## HINCKLEY NATIONAL RAIL FREIGHT INTERCHANGE – LAND WEST OF STONEY STANTON PRE-APPLICATION CONSULTATION RESPONSE

## TECHNICAL NOTE

**Project Title:** Hinckley NRF Interchange

### Initial Review of Interim Transport Assessment

**Figure 1 – The Residential Site (in red) and DCO land (in blue)**

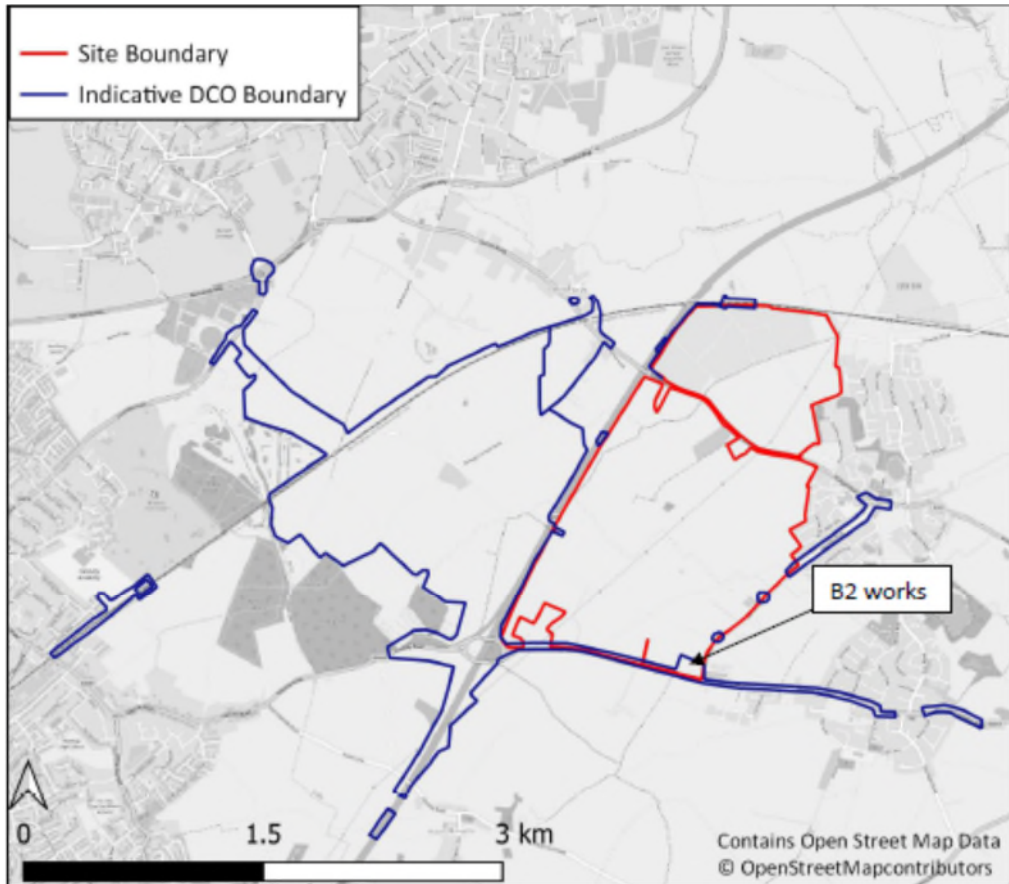
- 3.25. A large area of the Residential Site adjacent to the highway works at Junction 19 – B4669/Stanton Lane is marked as ‘B2 works’ at Figure 1 and also comes within the DCO land. From a review of the information submitted as part of the Consultation, it is unclear why that is the case when the only works in the area are new traffic signals at the junction.

- 3.26. We note that reference is made within Schedule 1, Part 2 of the draft DCO to a ‘temporary construction compound’ near the junction. However, it is not clear where exactly that compound is going to be situated nor why it needs to be in that area. On the basis of the information available, we see no justification for locating a construction compound on that land whilst there is a significant amount of space within the main body of the HNRFI site that could easily be utilised for such purposes.

- 3.27. Any construction compound in that area could sterilise the development of the Residential Site on that land for a significant period of time, which would be unacceptable to the Consortium.

- 3.28. It is also not clear whether that land is going to be used for any other purposes associated with the HNRFI, whether temporarily or permanently. The draft DCO refers to footpath improvements and signage; the details of which are not clear.

- a) In respect of that area of the DCO land marked 'B2 works' at Figure 1 above, a clear description of the nature of the works and/or land use in the vicinity of that junction, why that area comes within the DCO land (including clear justification for any construction compound to be located there), whether it will be acquired, either permanently or temporarily as part of the HNRFI scheme and, if temporarily, for how long.

**Fig 1.1 Extract from Public Exhibition.**

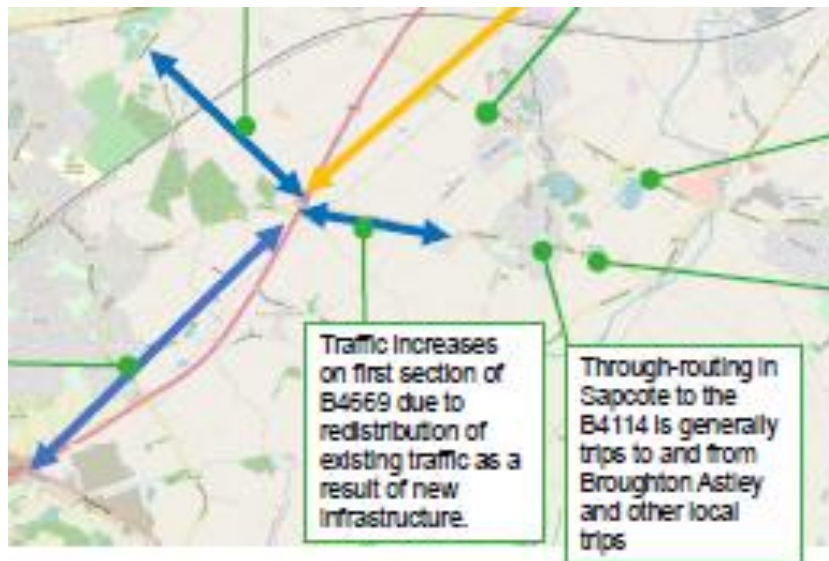
- 1.24 The comment on the consultation board seems to be suggesting that the traffic increases to the east of the M69 are due to traffic redistribution and not as a result of the HNRFI. However the changes are due to the new infrastructure which is a requirement of the HNRFI. Consequently any residual change in traffic which results in an adverse impact is a matter the HNRFI needs to address.

- 1.25 These changes to flows as a result of infrastructure measures as well as the development traffic need to be identified in traffic flow diagrams showing the changes in peak hour flows across the entire network (including individual 40 junctions) for the different assessment scenarios. Without this information it is difficult to fully understand and assess the full impact of the traffic reassignment resulting from the proposed access infrastructure and that of the development itself.
- 1.26 Such information would then assist in understanding the traffic redistribution as a consequence of the changes in infrastructure etc. As an example, analysis of the data illustrates an increase in traffic along the B4669 / Stanton Lane and further north (Hinckley Road, Lynchgate Lane,

Sharnford Road, Pingle Lane, Huncote Road) but with insufficient explanation as to why this is occurring. This needs to be reviewed and justified rather than accepted as a consequence of the PRTM traffic modelling. The PRTM model will reassign traffic via various routes to balance the traffic around the network rather than route the traffic along routes drivers will prefer the travel, albeit there may be increased congestion along such routes. Hence a review of the model is required to justify any anomalies within the model outputs.
